Access Compliance Report

Public Rights-of-Way

Intersection ID: N/A	Main Street: HICKORY GROVE RD	Cross Street: LAWRENCE ORR RD	Location: NE
ADA ID: F0CF95CA0B8D	Ramp Type: PerpDiag	Initial Pass/Fail: Fail	Overall Compliance: No
Severity Score: 13.75			
Codes/Mitigation Info/Possible Solution		Field Measurements/Component Compliance

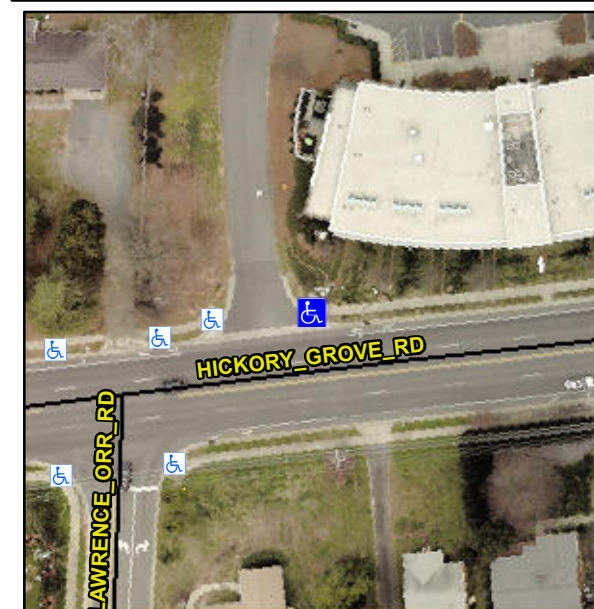
R304.2.2, R304.5.3

Compliance	Description	Data	Compliance	Description	Data
N/A	Ramp Length (in)	47.5	No	Ramp Slope (%)	10.2
Yes	Ramp Width (in)	48.0	No	Ramp XSlope (%)	3.5
N/A	Flare Type LT	N/A	N/A	Flare Type RT	N/A
N/A	Flare Slope LT (%)	N/A	N/A	Flare Slope RT (%)	N/A
N/A	Flare Traversable LT?	N/A	N/A	Flare Traversable RT?	N/A
N/A	Landing Length (in)	N/A	N/A	DWS Provided?	N/A
N/A	Landing Width (in)	N/A	N/A	DWS Contrast?	N/A
N/A	Landing Slope (%)	N/A	N/A	DWS Length (in)	N/A
N/A	Landing X Slope (%)	N/A	N/A	DWS Full Width?	N/A
N/A	Landing Curb? (Y/N)	N/A	N/A	DWS Offset (in)	N/A
N/A	Shared Landing?	N/A			
N/A	Gutter Ponding?	N/A	N/A	Gutter Slope (%)	N/A
N/A	Gutter Lip Ht (in)	N/A	N/A	Gutter X Slope (%)	N/A
N/A	Painted X Walk1?	No	N/A	Painted X Walk2?	No
	X Walk 1 Direction	To W		X Walk 2 Direction	To S
N/A	X Walk 1 Width (in)	N/A	N/A	X Walk 2 Width (in)	N/A
	X Walk 1 Slope (%)	1.4		X Walk 2 Slope (%)	4.2
	X Walk 1 X Slope (%)	7.9		X Walk 2 X Slope (%)	1.4

Remove & Replace Curb Ramp With Two New Directional Ramps or Equivalent.
